Intel[®] Pentium[®] 4 Processor Specification Update

Release Date: February 2002

Order Number: 249199-019

The following figure will be added as Figure (new). THERMTRIP# Power Down Sequence

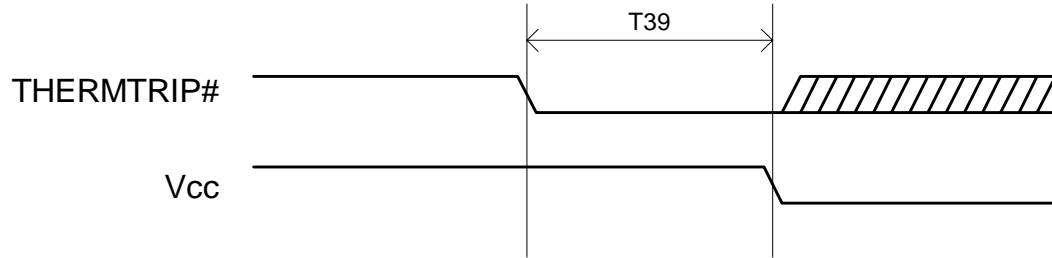
Several parts of the *Intel® Pentium® 4 Processor in the 423-pin Package* datasheet will be updated as follows to clarify the functionality of the Thermtrip# pin.

The following specification will be added to Table 13, page 24.

<u>T# Parameter</u>	<u>Min</u>	<u>Max</u>	<u>Unit</u>	<u>Figure</u>	<u>Notes</u>
T39: THERMTRIP# to removal of power	N/A	500	ms	(new)
